## 7/16" UNF-FIXING KIT for MICROSWITCH ACTUATING ROD

FITTED TO DEANS CYLINDER- CRANK ARM

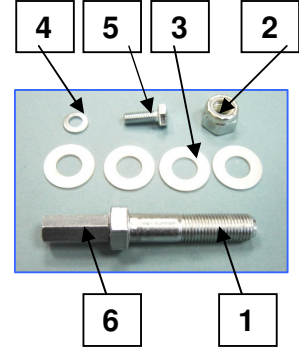
### EXISTING DEANS

Installation of Micro-switch actuating rod/fixings

### UPGRADE KIT TDS

Installation for Micro-switch actuating rod/fixings

1. Use Loctite 270 for fixing items 6 to 1 & 5 to 6
